> September 22, 2008 BVY 08-059

#### Subject: Vermont Yankee Nuclear Power Station Docket No. 50-271, License No. DPR-28 Technical Specifications Proposed Change No. 280 Relocation of Reactor Building Crane Technical Specifications

## Markup of the Current Technical Specifications and Bases Pages

#### F. Fuel Movement

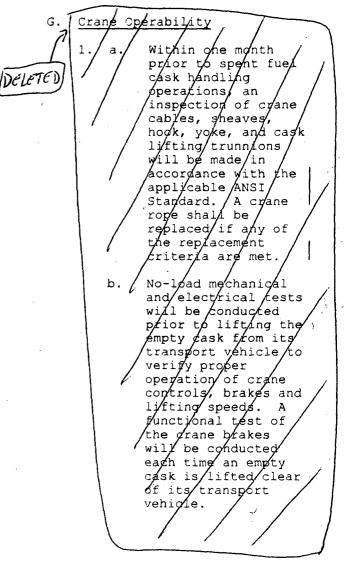
- 1) Pages 235 and 236, TS 3/4.12.G: This TS is being relocated to the TRM.
- 2) Page 239, Bases for TS 3/4.12.G: This Bases is being relocated to the TRM.

ane Operabilit ELETED Reactor Bylilding The crahe shall be operable when the crane is used for handling of a spent fuel cask/

G. Deleted

G. Deleted
